Redline Markups

2023 City of Seattle Standard Plans for Municipal Construction

The Standard Plans shown here depict the proposed edits of the 2020 Standard Plans used to create the 2023 Construction Standards.

FIRE HYDRANT LOCATIONS & CLEARANCES

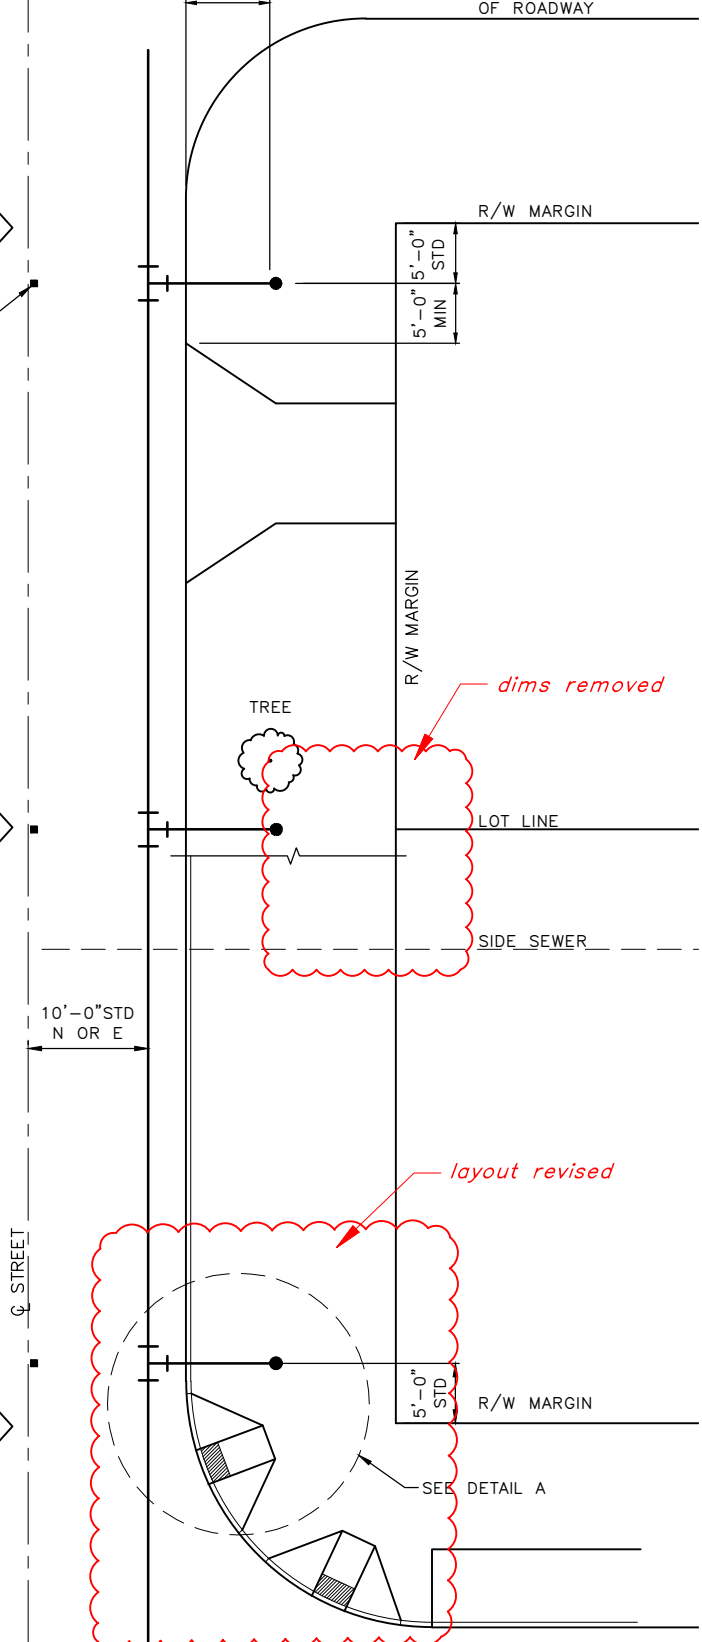
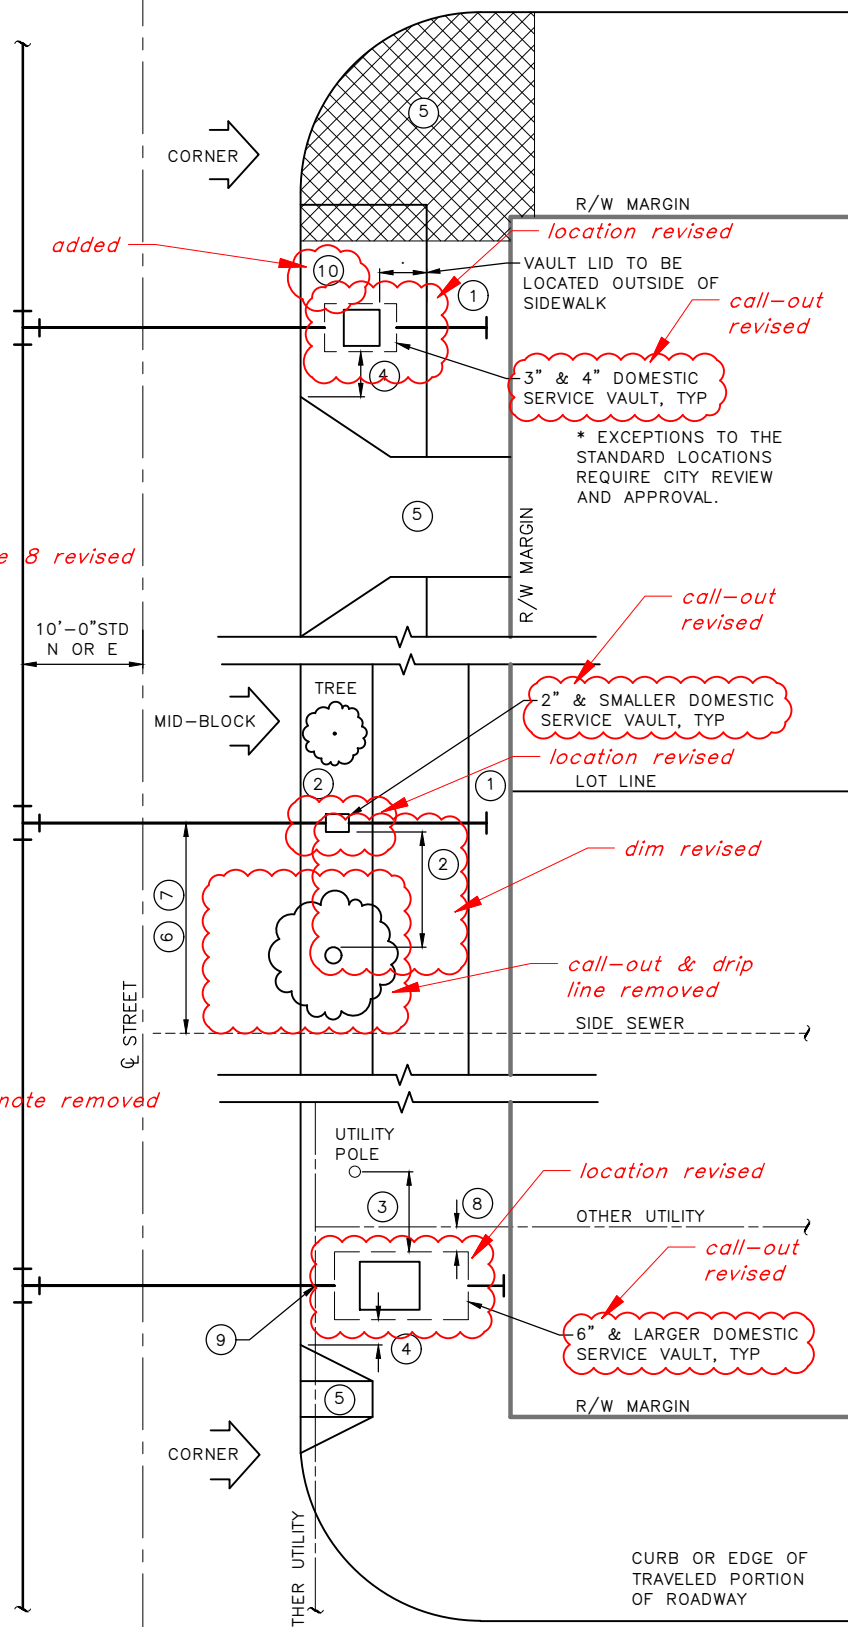
notes added/revise

detail revised

WATERMAIN TRENCH AND BEDDING

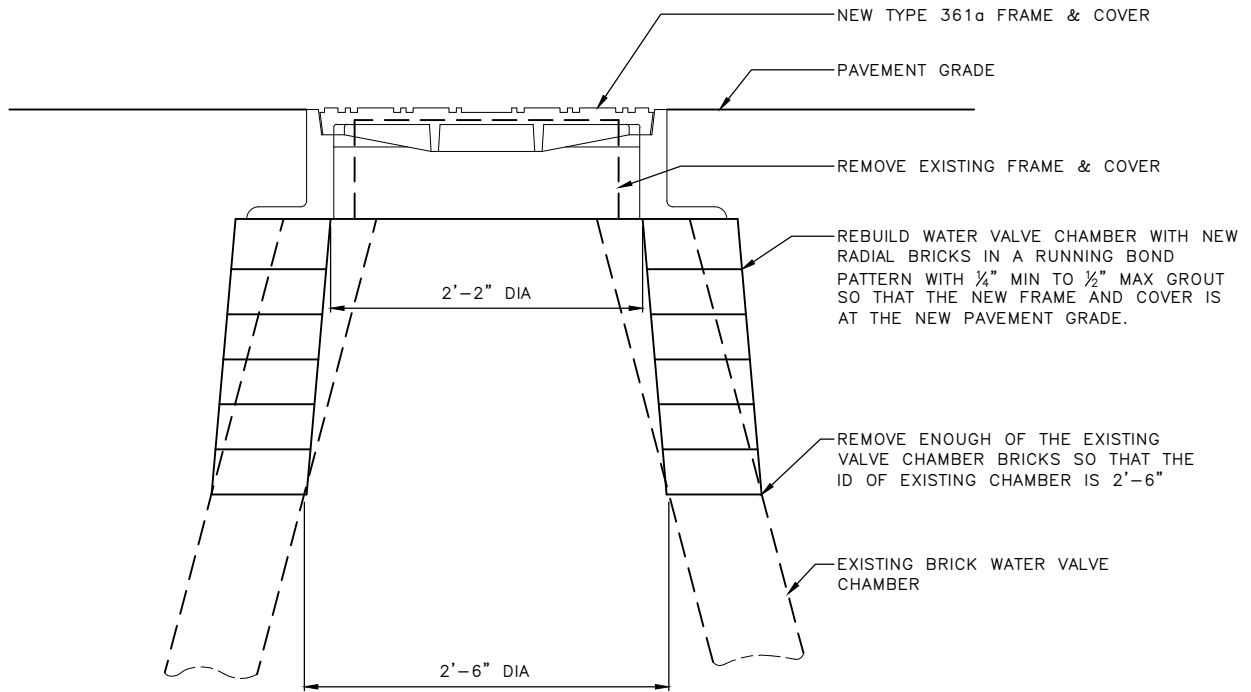
revised from 9-03.16

ROADWAY CEMENT CONCRETE ALLEY PAVEMENTS

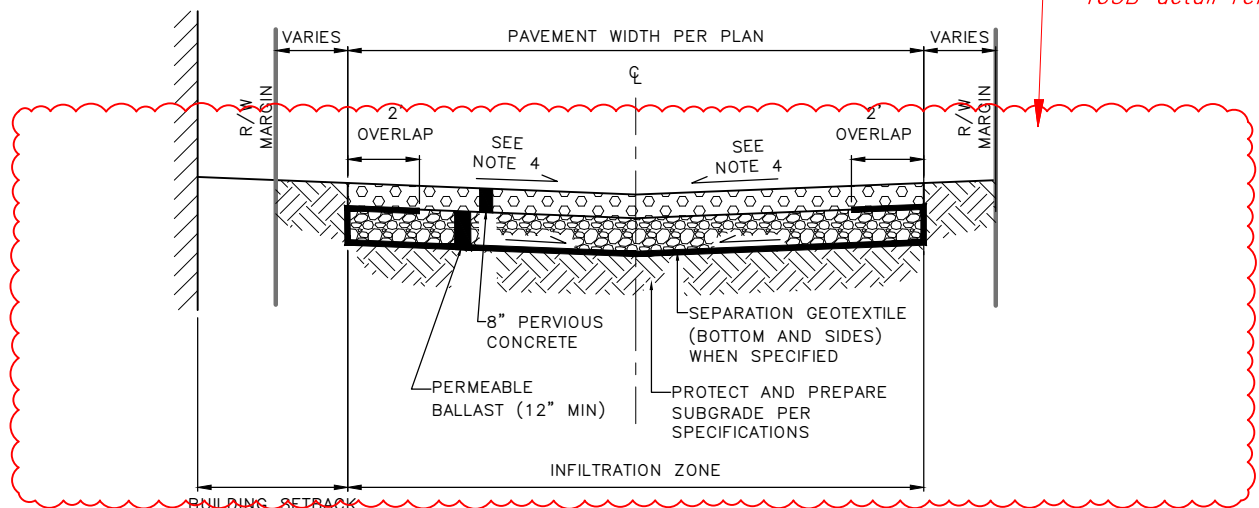
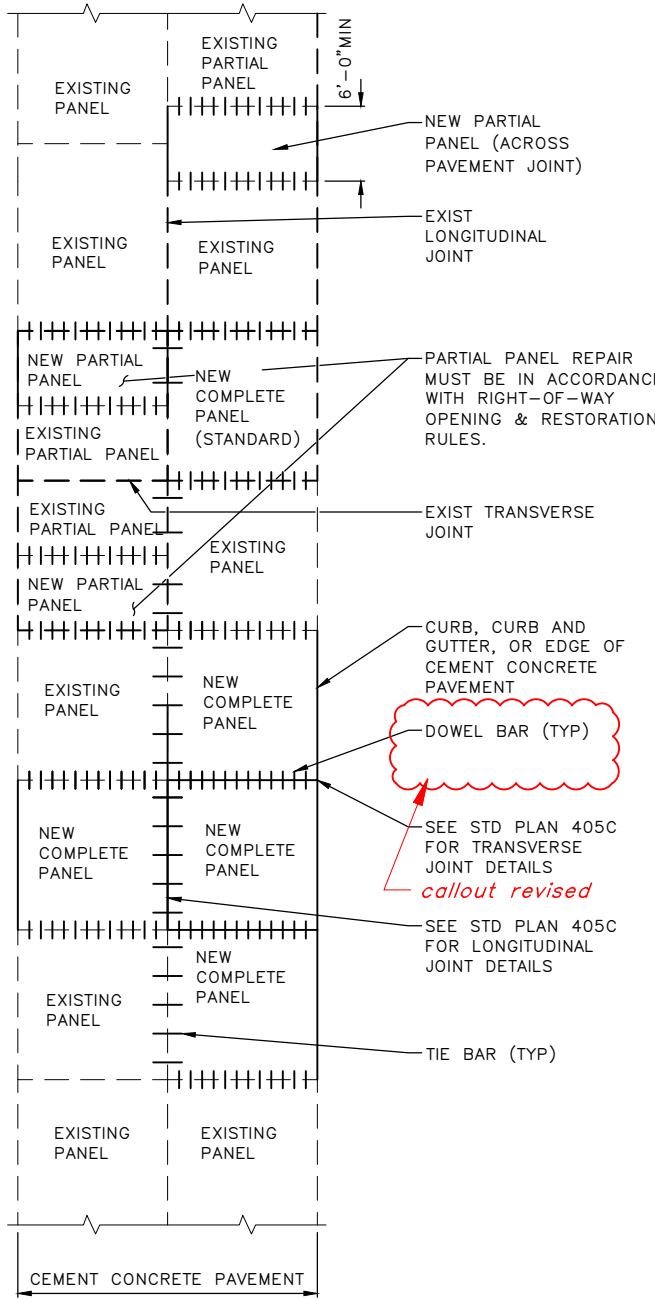
subgrade revised

callout revised

CEMENT CONCRETE ALLEY PAVEMENT 403B detail removed

**FRAME & COVER CEMENT
CONCRETE REINFORCEMENT
DETAIL**

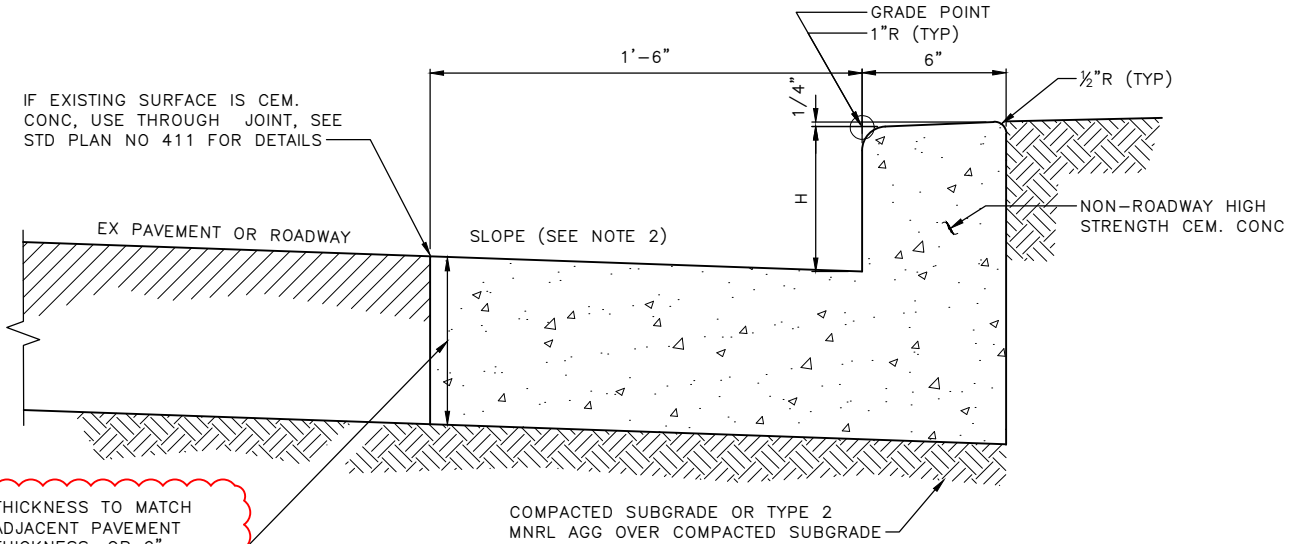
note 3 revised

ISLAND CUT-THROUGHS
 (TYPE 422H)

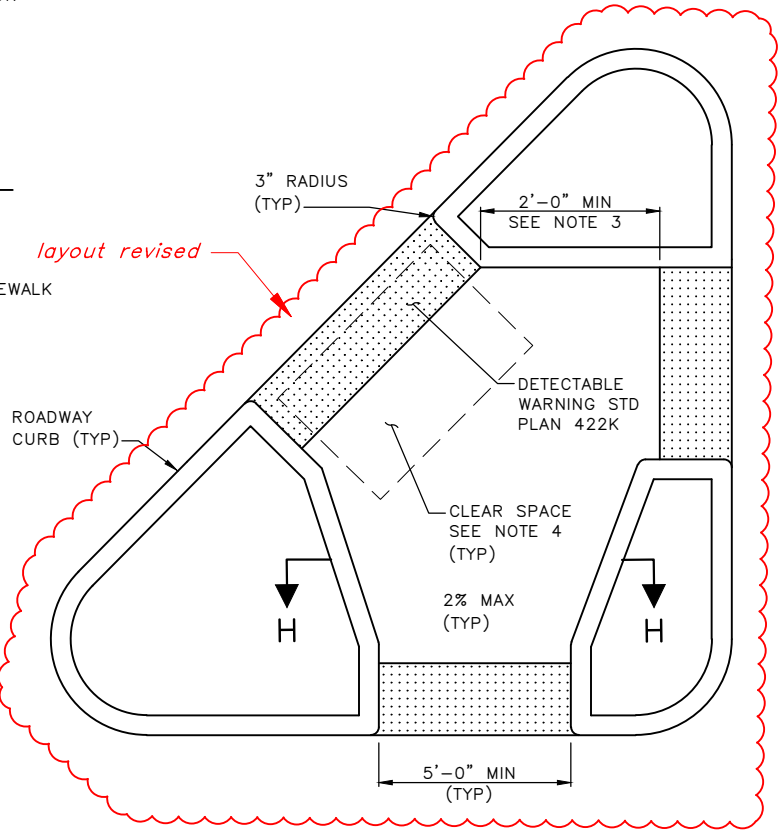
layout revised

note 3 revised

layout revised

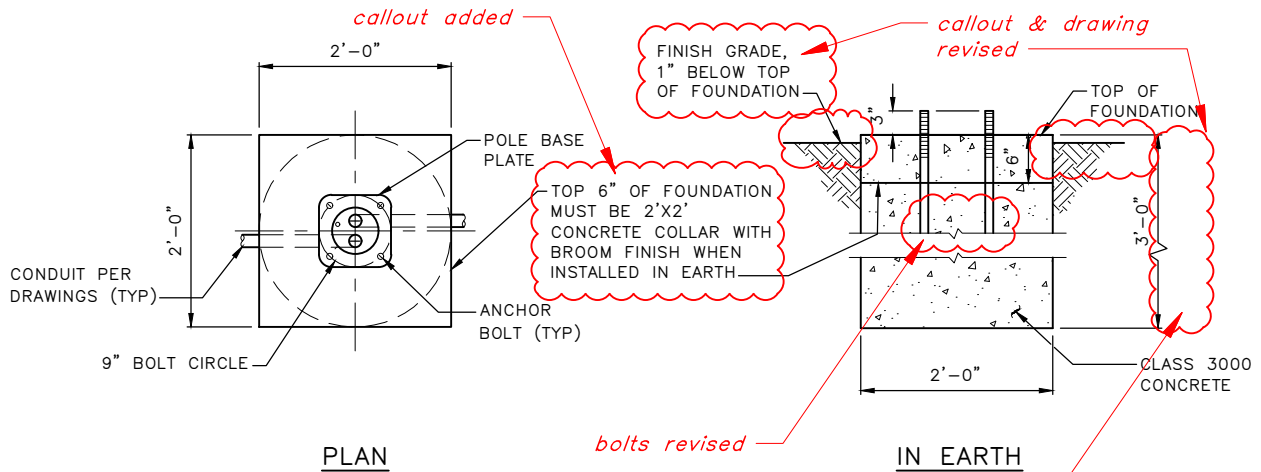
former note 1 removed

note added

TYPICAL CURBSIDE RED BUS LANE LAYOUT

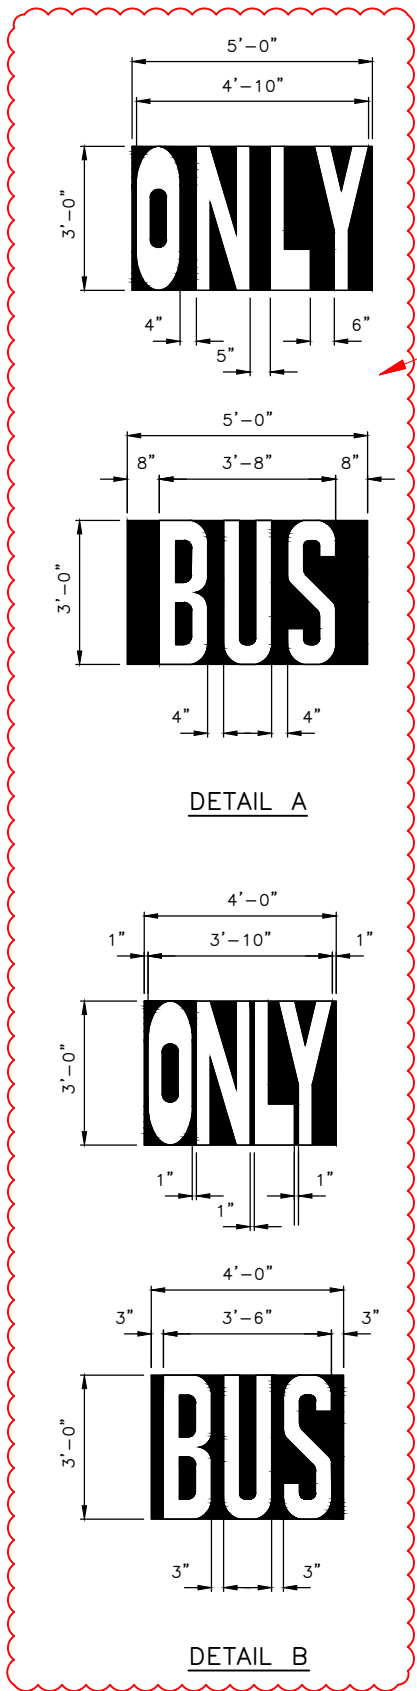
details added

callout added

callout revised

dims revised

callout revised

note 1 revised, note 2 added

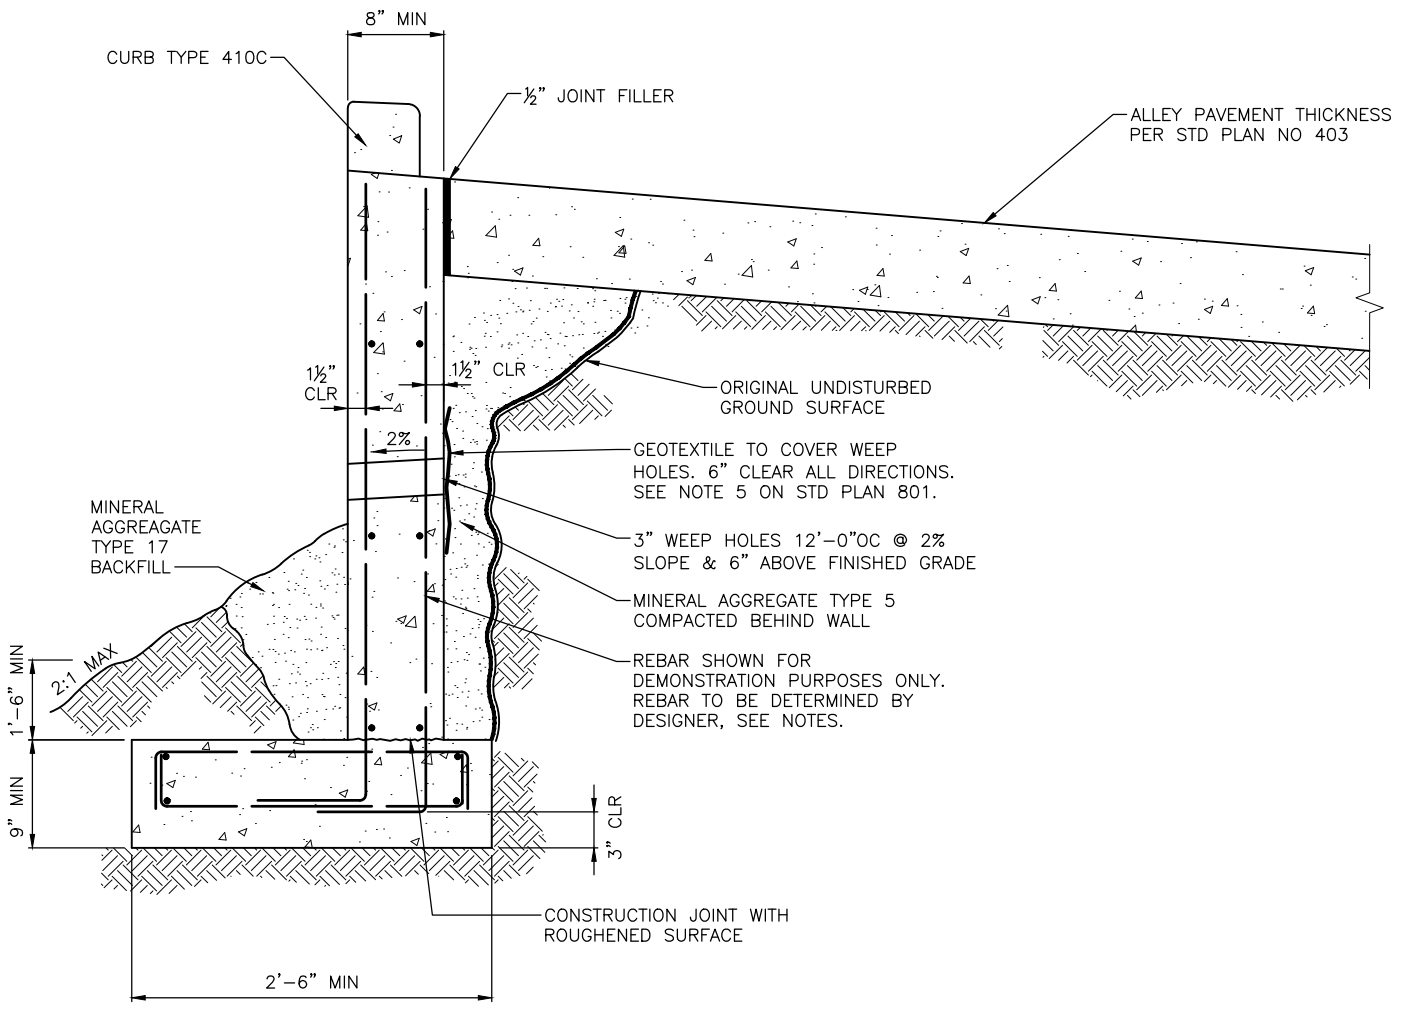
typo corrected
